H11717

DESCRIPTIVE REPORT

General Locality Akutan Pass

Sublocality Unalga Island to Cape Sedanka

Figure 7 H11717 Chart Comparison (Chart 16528)

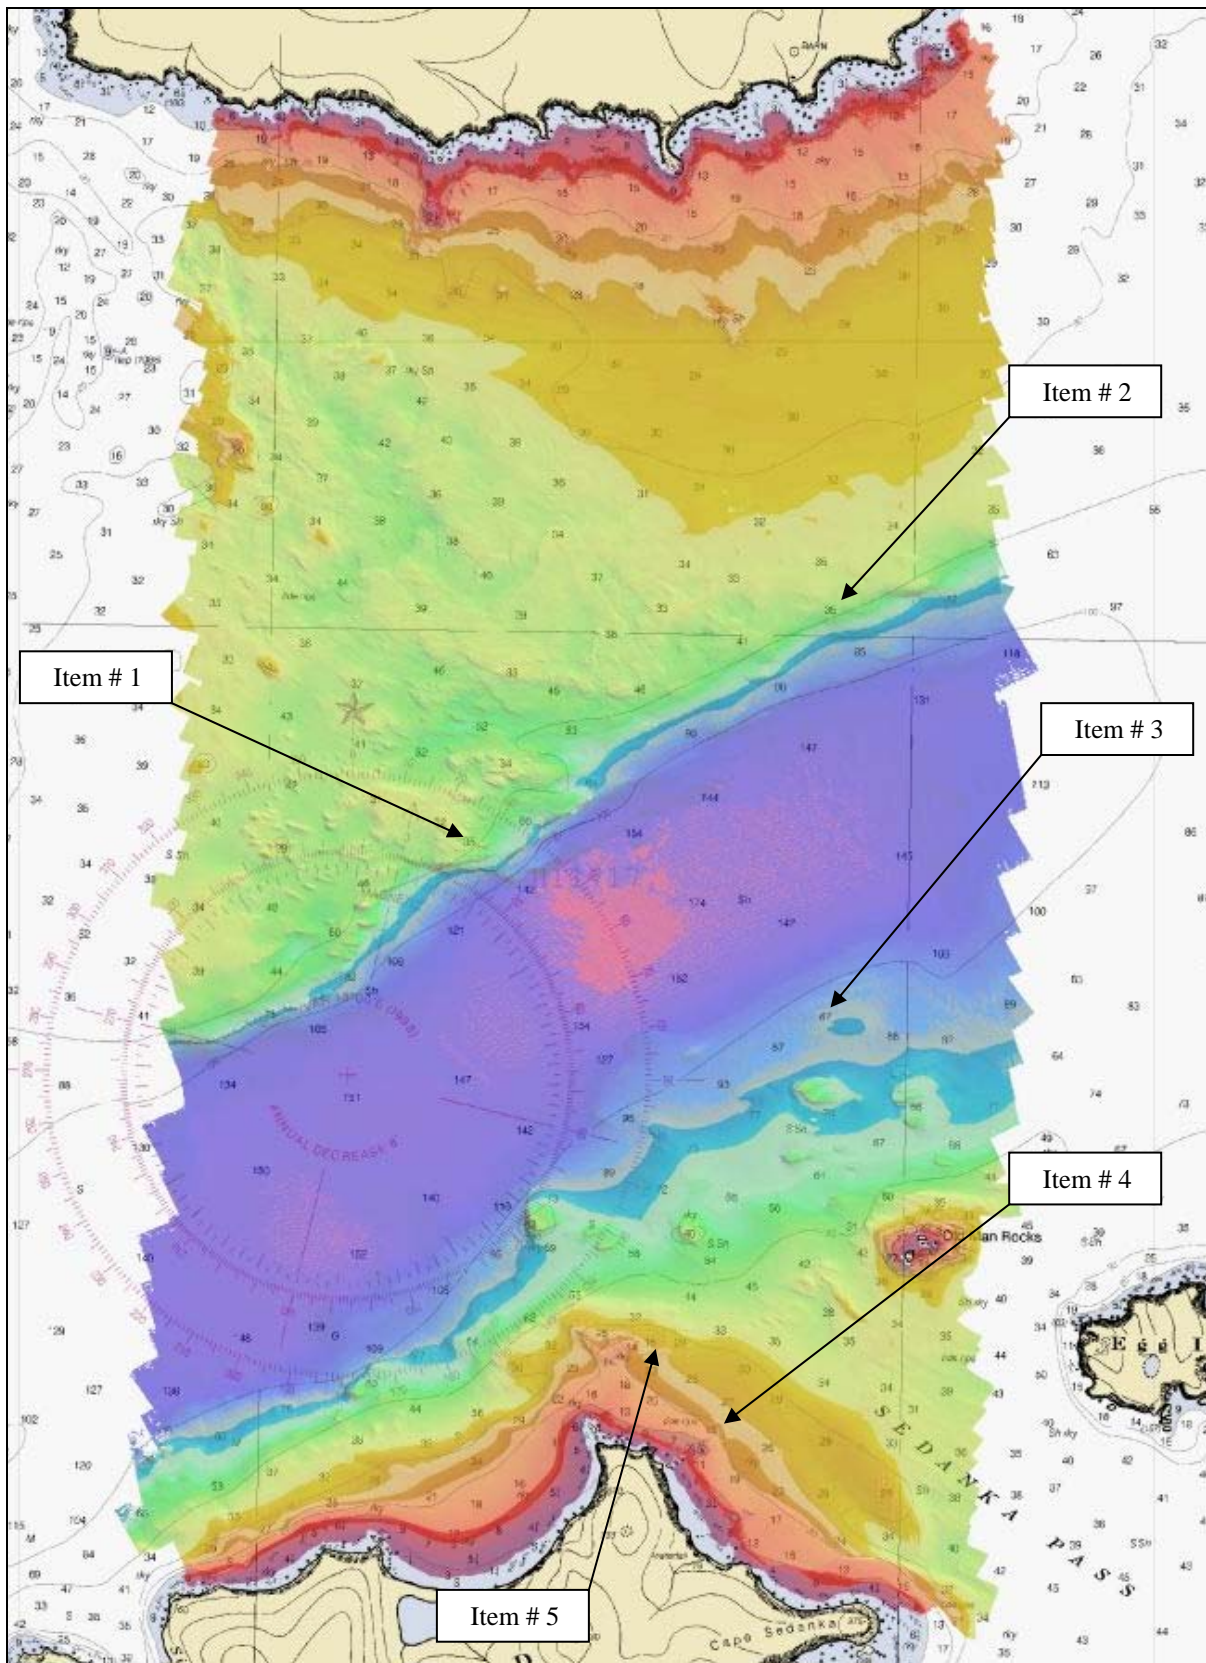
- Item # 4: Hydrographic survey H11717 revealed a depth of 22 fathoms in the vicinity of a 15 fathom sounding on chart 16528 located at 53°51'20" N, 166°06'28" W. This area was surveyed with 100% multibeam coverage.¹⁴

¹⁴ Do not concur, a 14 fathom sounding present at this location. Chart per HCell.
